DOCUMENTS FOR REVIEW AND FILES LOCATION

Please charge time to 5600015- 102. Design Consultant response period: 12-22-2014 to 1-12-2015.

TOWN OF COLCHESTER COUNTY OF CHITTENDEN PROPOSED IMPROVEMENT SIDEWALK AND RESURFACING PROJECT STP 5600(15)

**CONCEPTUAL PLANS
NOVEMBER 24, 2014**

FILE NAME: General Plans.dgn PLOT DATE: 11/24/2014  
PROJECT LEADER: J. LEINWOHL DRAWN BY: T. DUGUAY  
DESIGNED BY: T. DUGUAY CHECKED BY: J. LEINWOHL  
ETHAN ALLEN AVE. SDWK PLAN EA-02 SHEET 30 OF 35

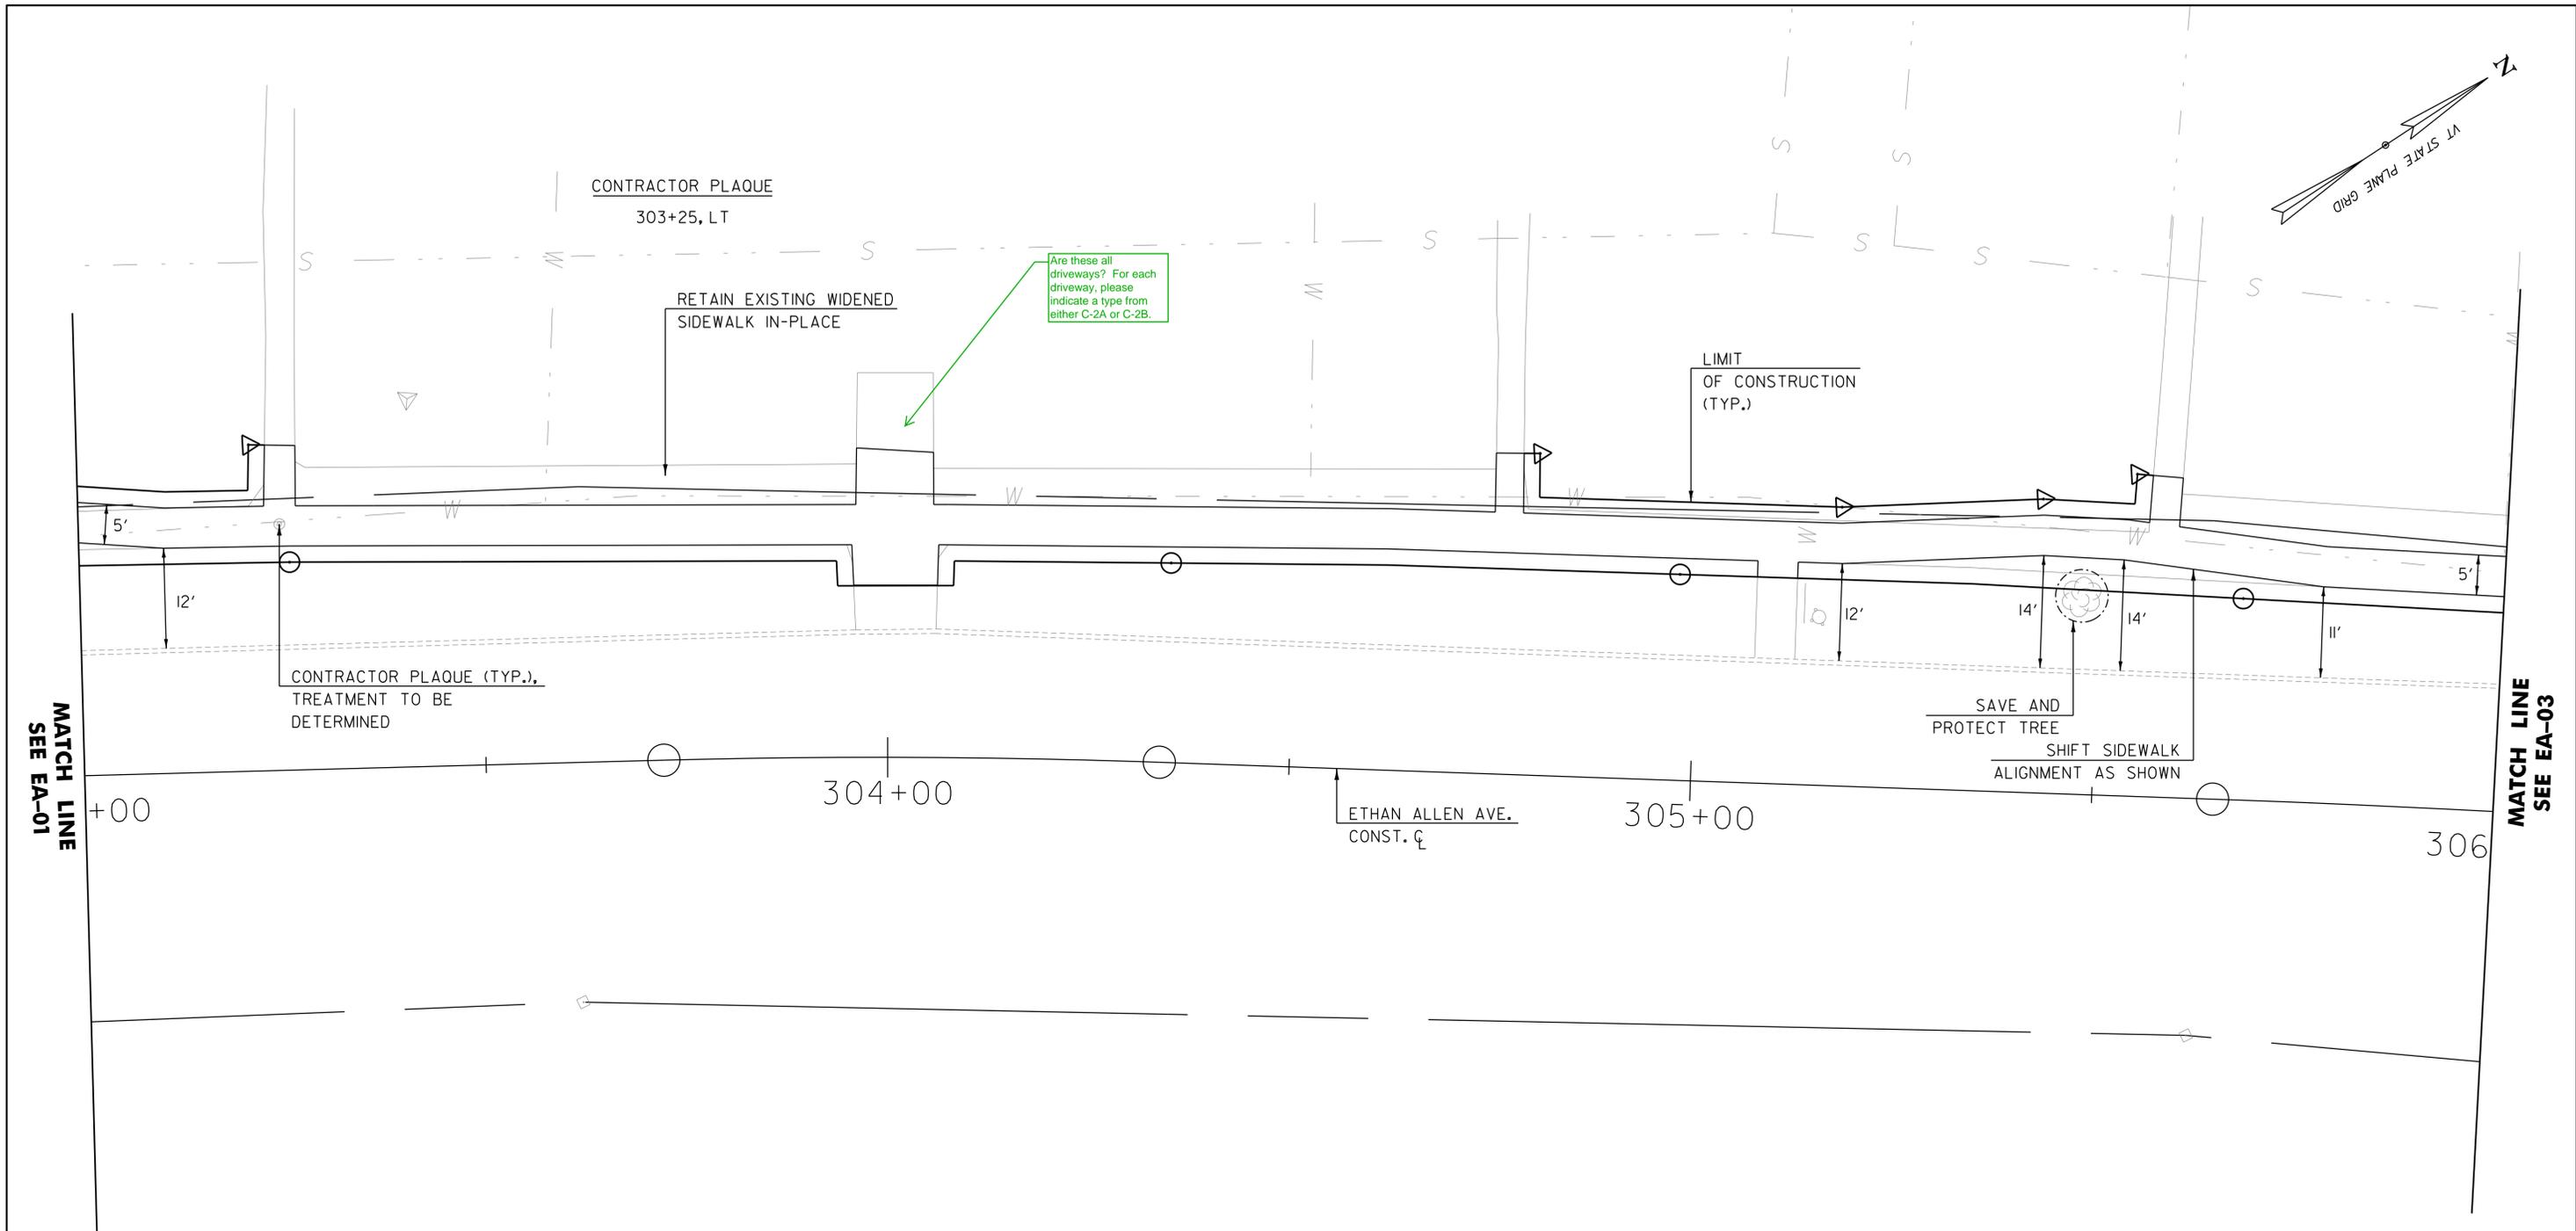
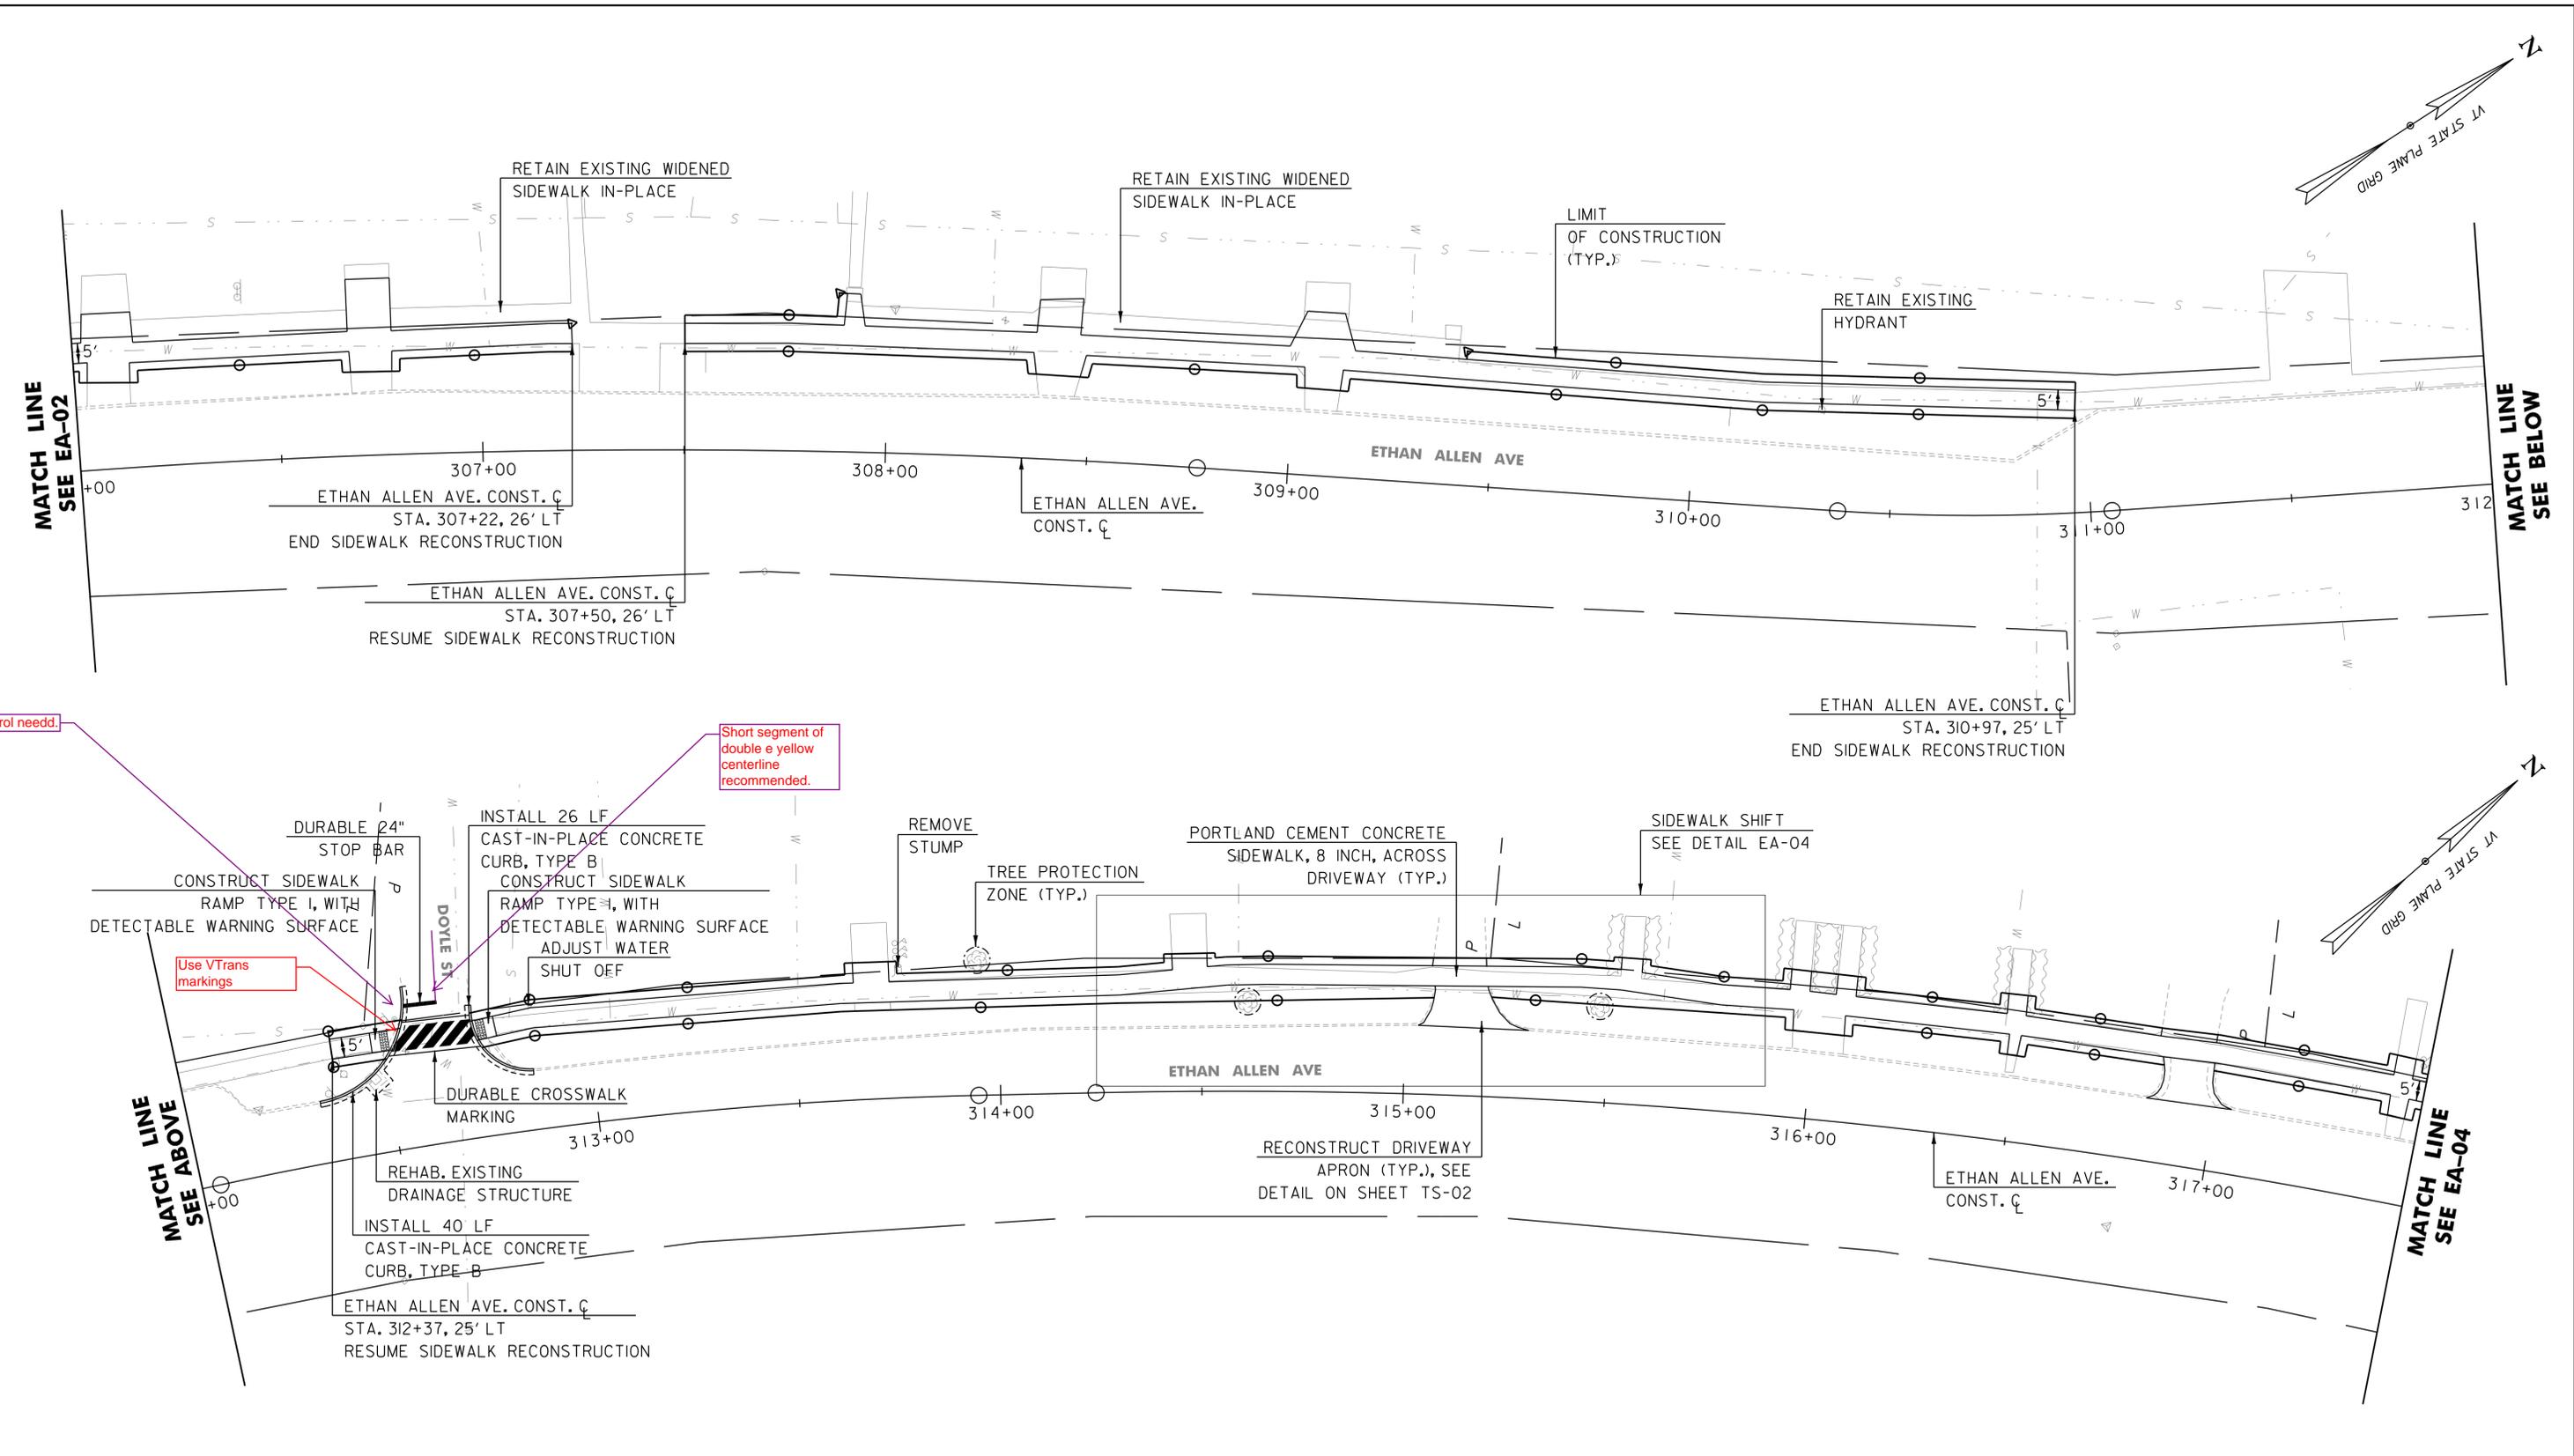
Within ROW?

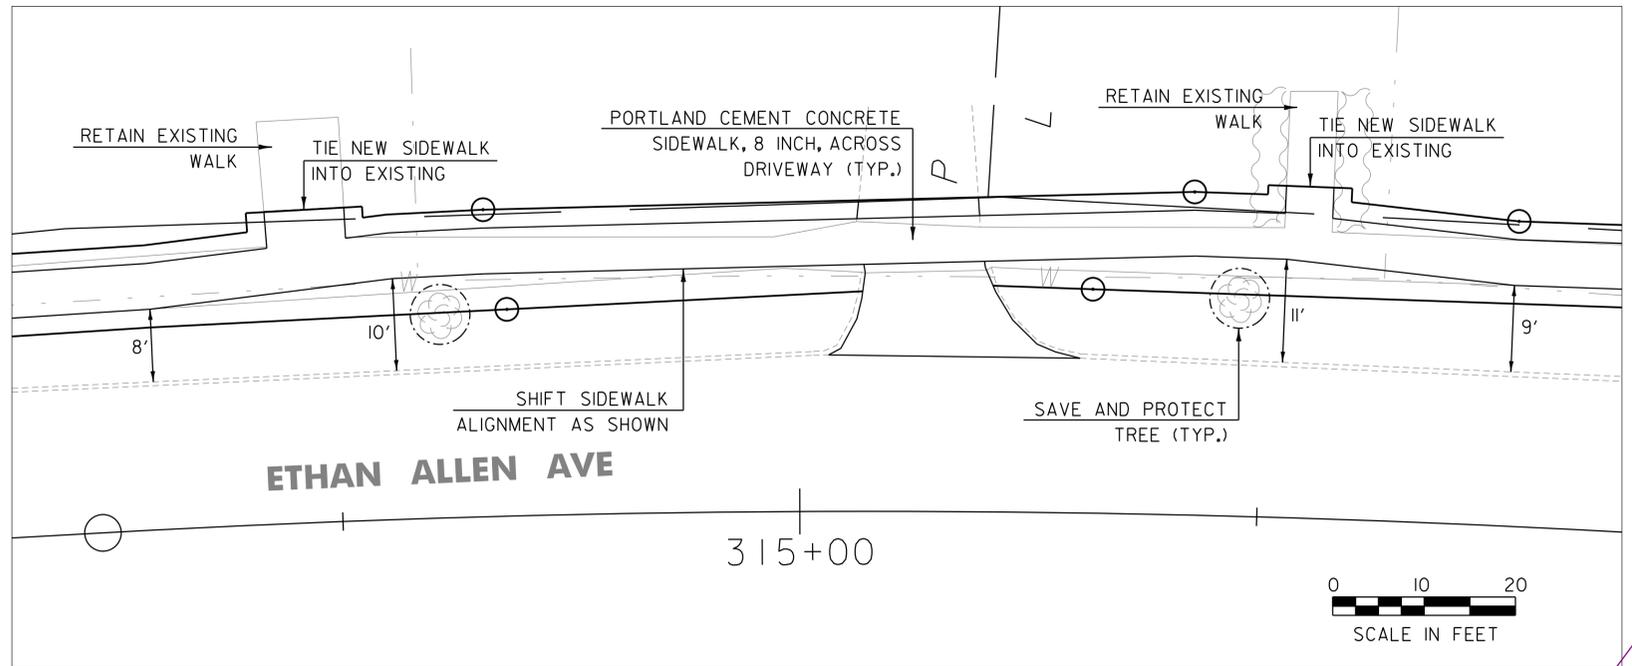
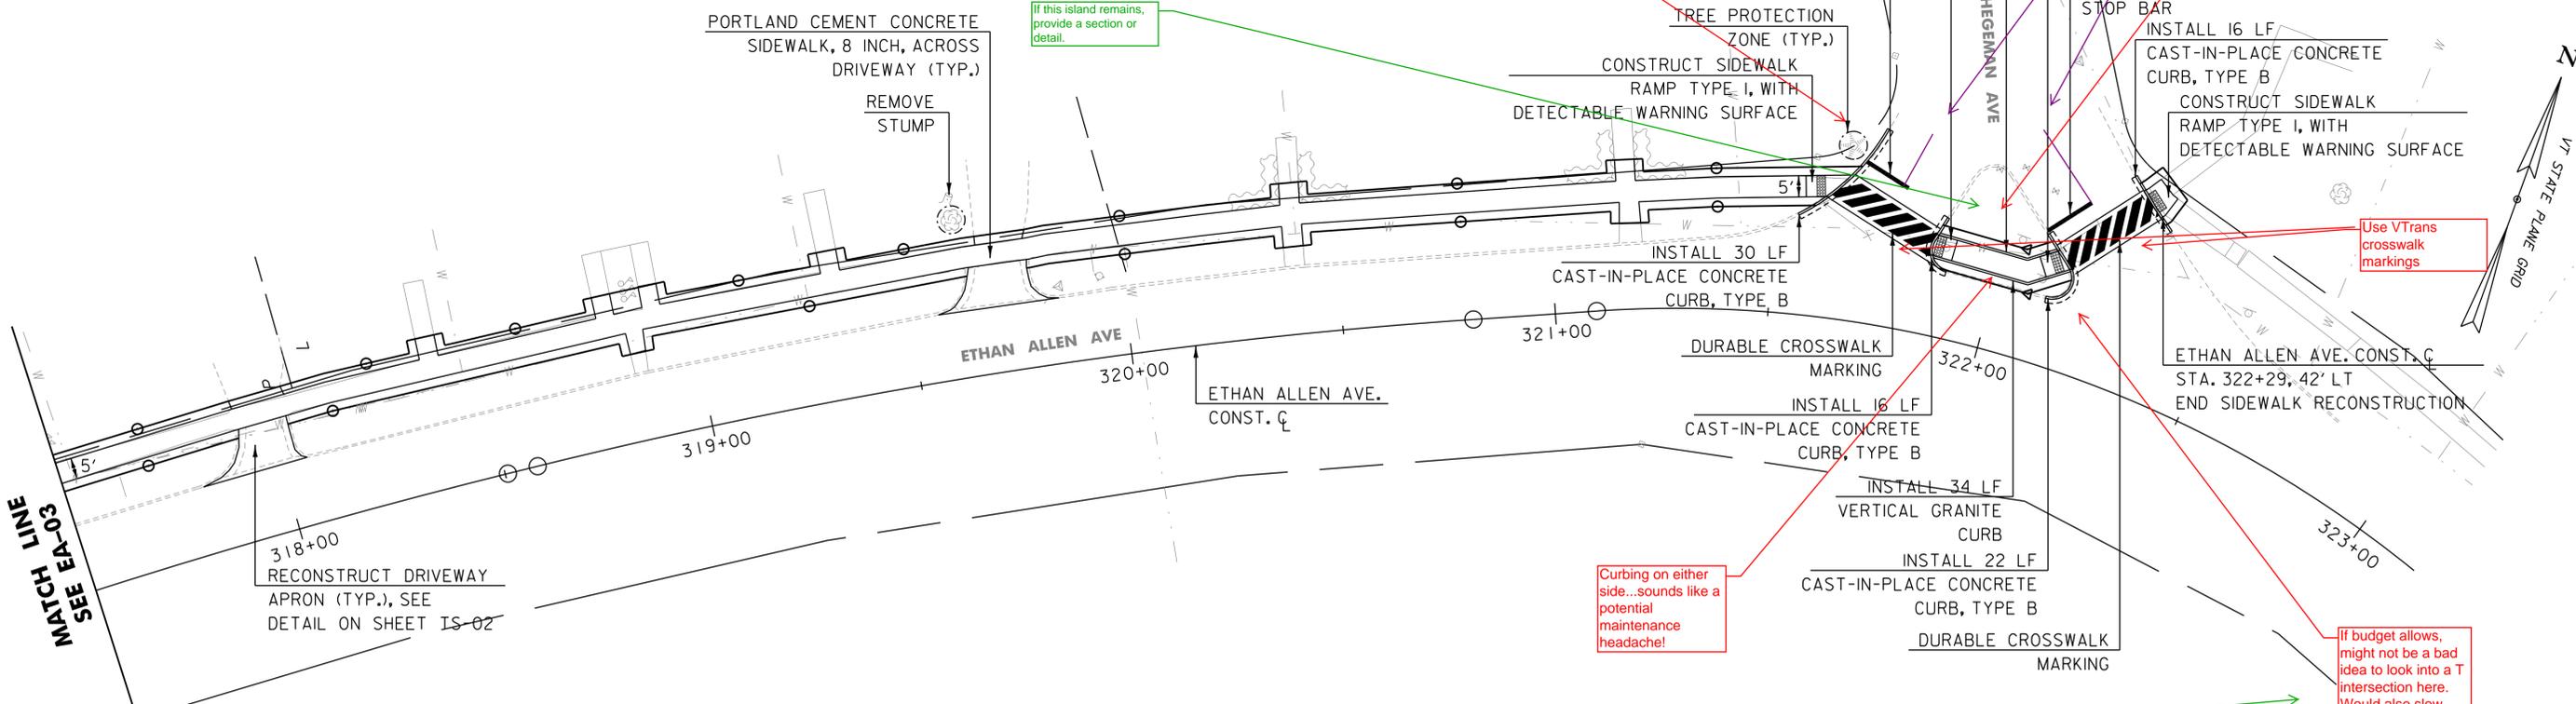
Short segments of double yellow centerline recommended (approx 40 ft long) (TYP.)

Signage will have to be addressed

Tree won't pose a sight distance issue with the stop bar moved back?

If this island remains, provide a section or detail.

Use VTrans crosswalk markings
